ACCESSION NBR: 8206070572 DOC. DATE: 82/06/03 NOTARIZED: NO DOCKET #
 FACIL: 50-387 Susquehanna Steam Electric Station, Unit 1, Pennsylvania 05000387
 50-388 Susquehanna Steam Electric Station, Unit 2, Pennsylvania 05000388
 AUTH. NAME: CURTIS, N.W. AUTHOR AFFILIATION: Pennsylvania Power & Light Co.
 RECIP. NAME: SCHWENCER, A. RECIPIENT AFFILIATION: Licensing Branch 2

SUBJECT: Submits util position re remote shutdown compliance, in response to 820311 request.

SUSQUEHANNA STEAM ELECTRIC STATION
REMOTE SHUTDOWN COMPLIANCE
ER 100450 FILE 841-2, 265
PLA - 1071

HOT & COLD SHUTDOWN MECHANISMS FROM OUTSIDE THE MCR

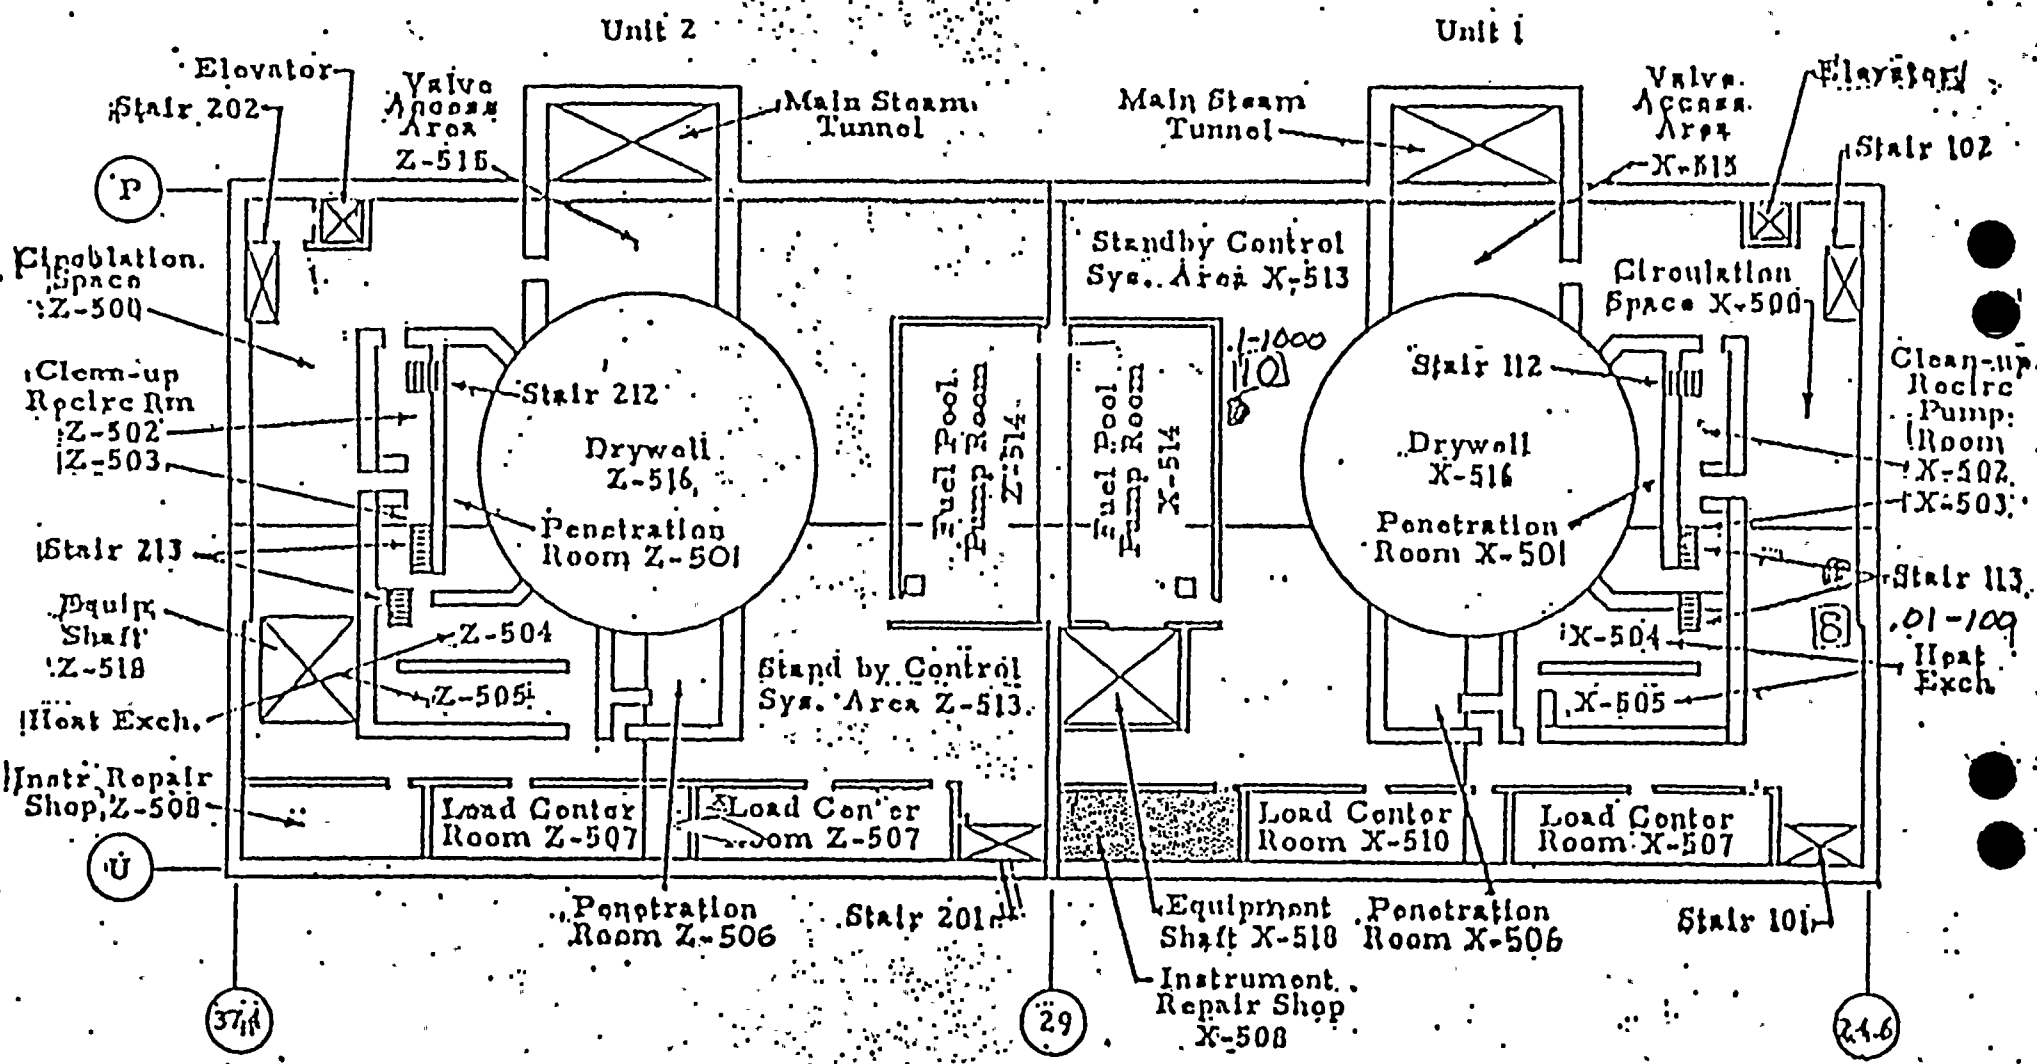
Attachment 1 tabulates the primary and redundant paths through hot and cold shutdown from outside the main control room. The systems are safety grade with the exception of the placement of the three safety relief valves in the primary path, which was intended to denote the preferred method of operation. While the use of the three safety relief valves does have a limited safety grade capability through the use of accumulators, the backup method (actuation of ADS) provides a redundant safety grade capability for depressurization. Within ADS there are six valves, each of which has redundant divisionalized control from the relay rooms. If a valve was to fail (i.e. stick closed for any reason), any of the other valves could be

REACTOR BUILDING - UNIT #1
EL. 670'

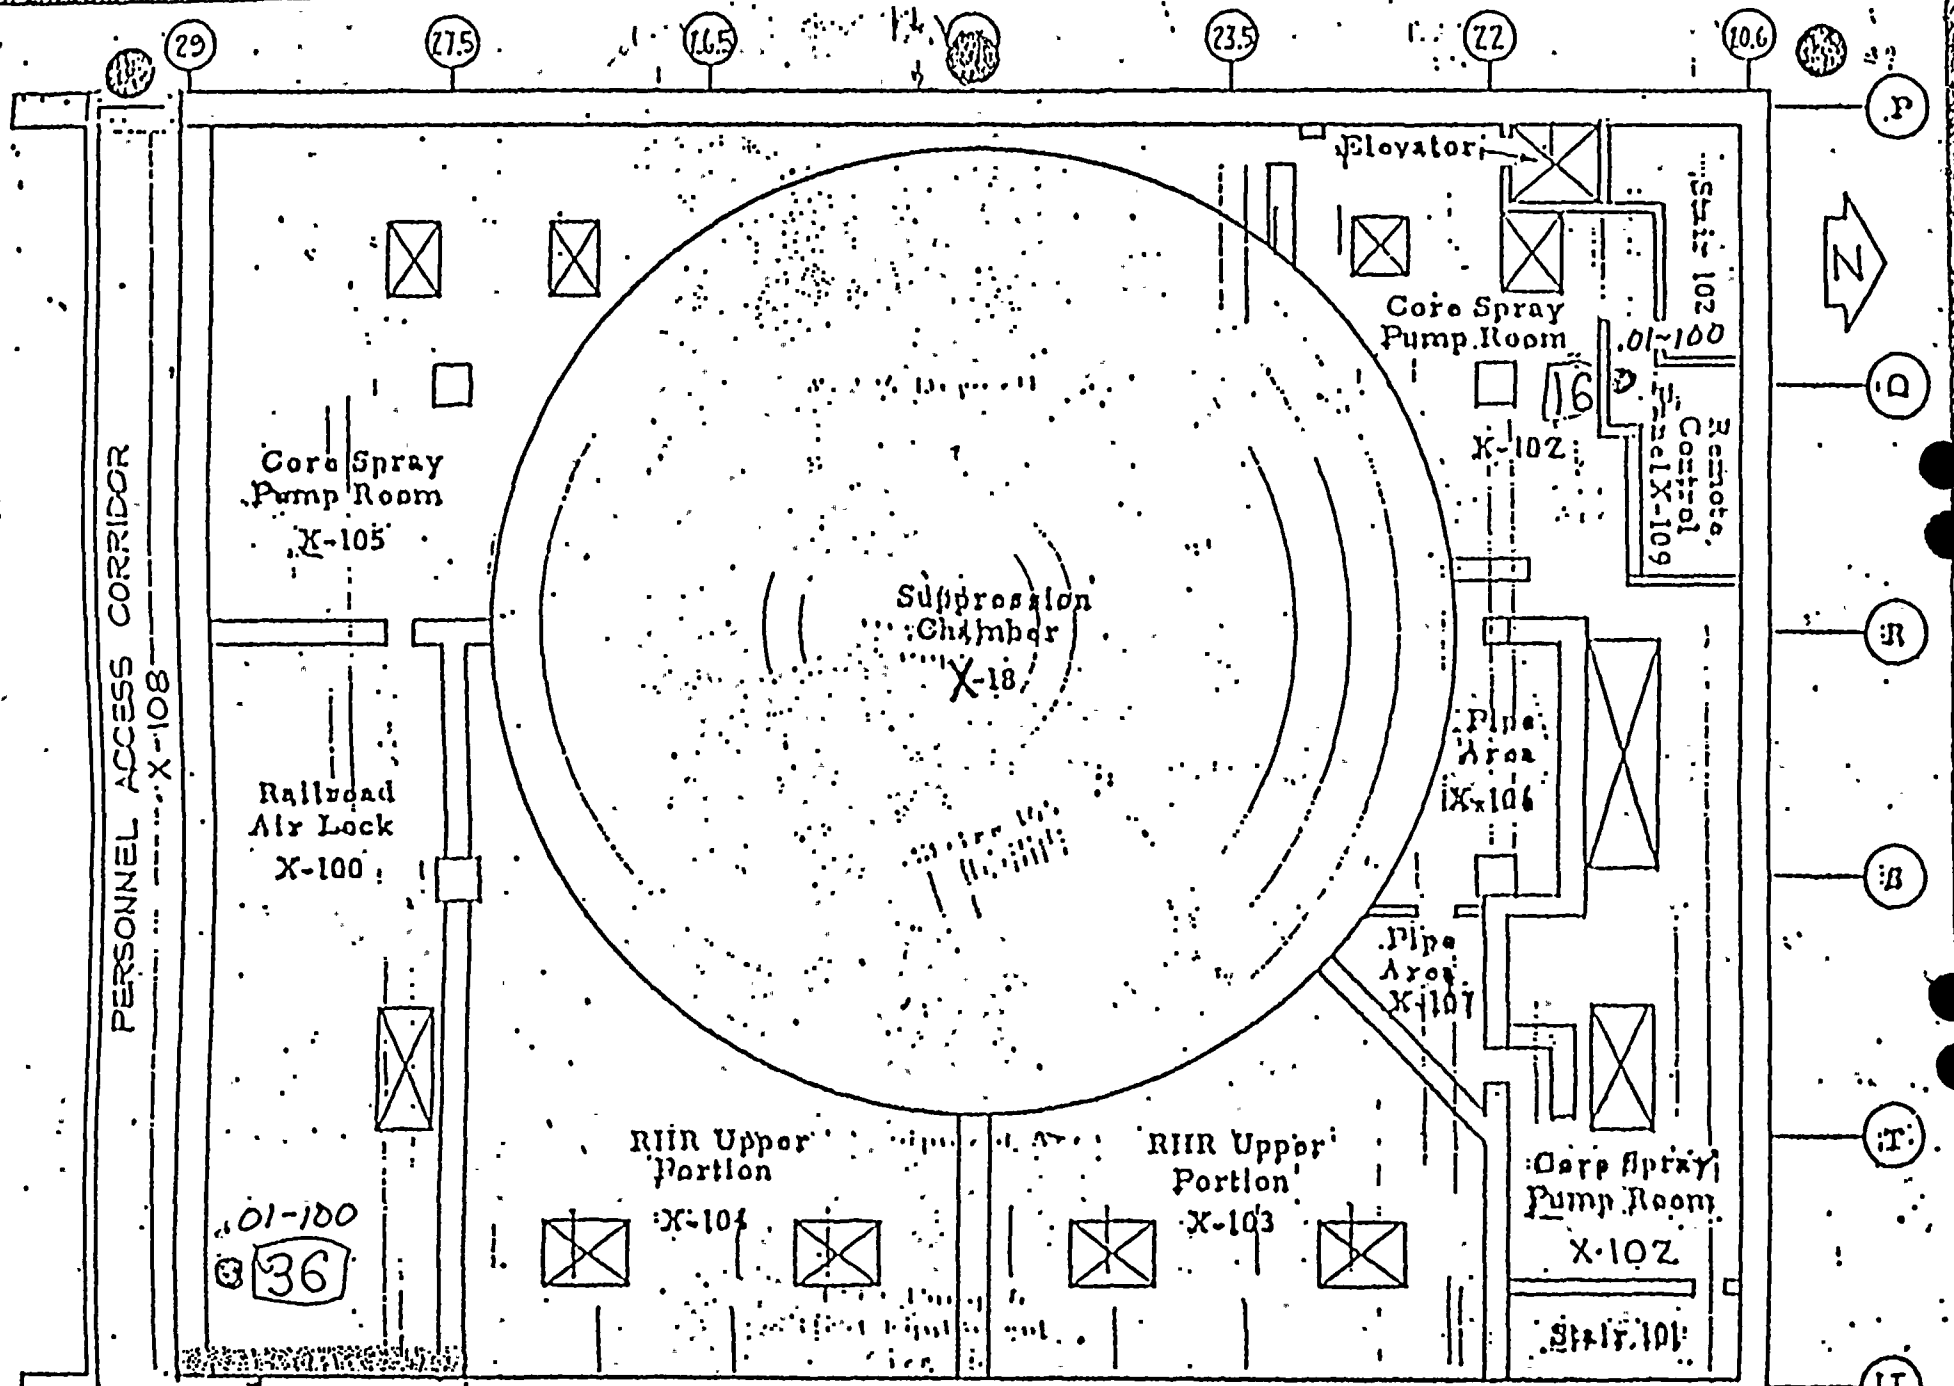
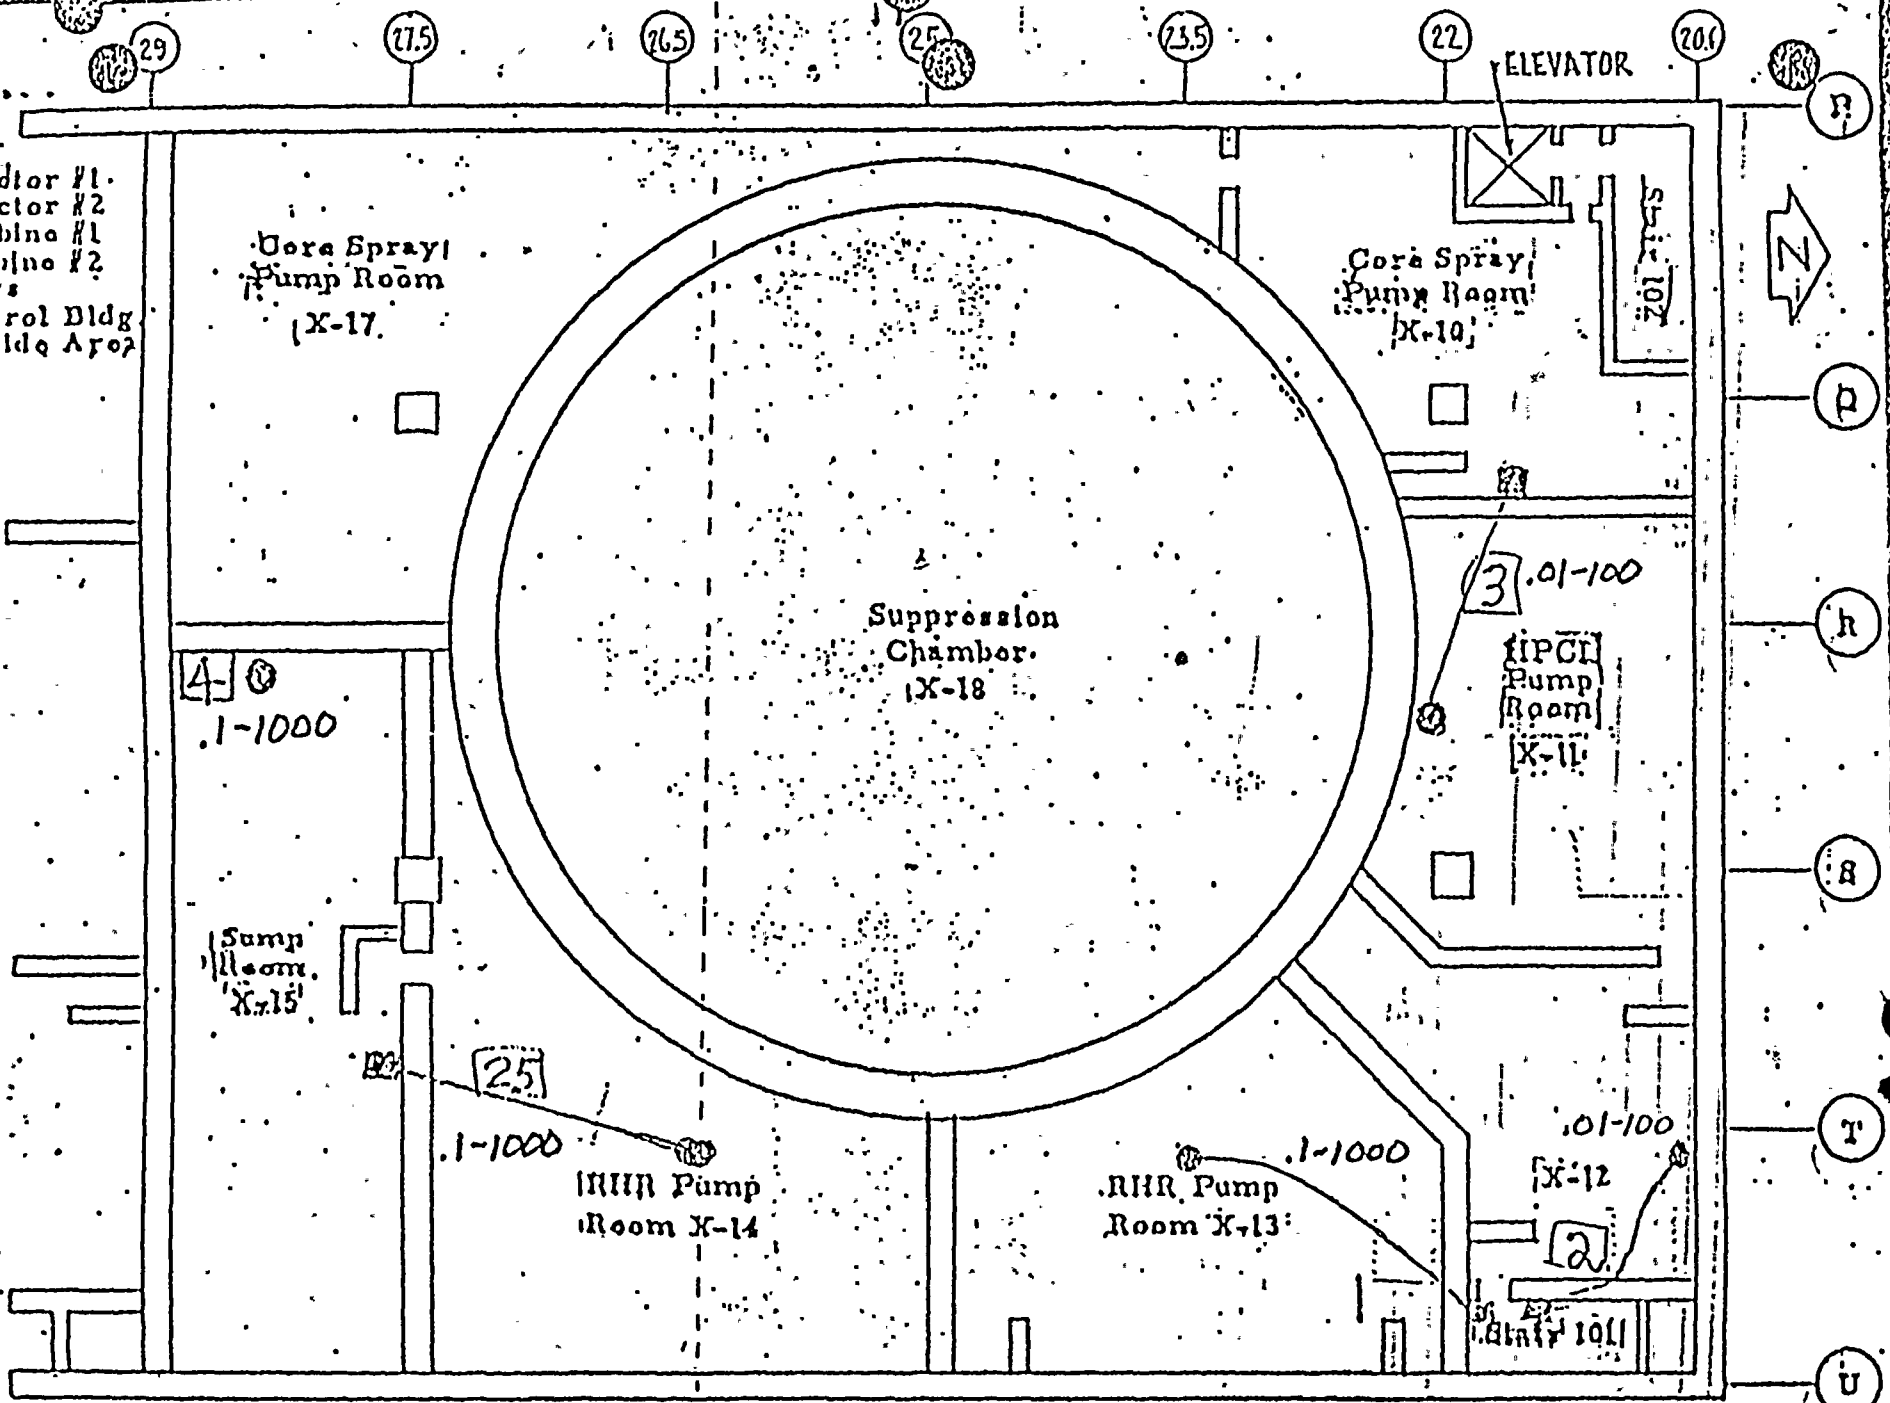
Table 1 provides the locations including elevations for hot and cold shutdown mechanisms in the redundant path which are not controlled from the Remote Shutdown Panel. The accompanying figures are provided to depict the tabulated information.

REDUNDANT PATH	LOCATION	ELEVATION	REFERENCE PAGE	ROOM
RHR Suppression Pool Cooling Loop - A	RHR Room	645'	5	X-14
	RHR Auxiliary	683'	3	X-202
	Switchgear	749'	1	X-510
RHR Service Water Loop A	RHR Room	645'	5	X-14
	Switchgear	719'	2	X-407
	Valve Pit	Ground Elevation	N/A	Near Spray Pond
ESW Loop A	Switchgear	749' / 719'	1/2	X-510 X-407
RPV Level	1C004/5	749'	1	X-513
Suppression Pool Temperature Division II	1C201	670'	4	X-109
MSIV Outboard	Valve Access Area	749'	1	X-515
Alternate S/D Cooling	Upper/Lower Relay Room	754' / 689'	N/A	Control Structure
	Core Spray Room	645'	5	X-10/X-17
	Valve Room	749'	1	X-515
	Switchgear	719' / 749'	1/2	X-510 X-407
ADS	Upper/Lower Relay Room	754' / 698'	N/A	Control Structure
Remote Shutdown Panel	1C201	670'	4	X-109
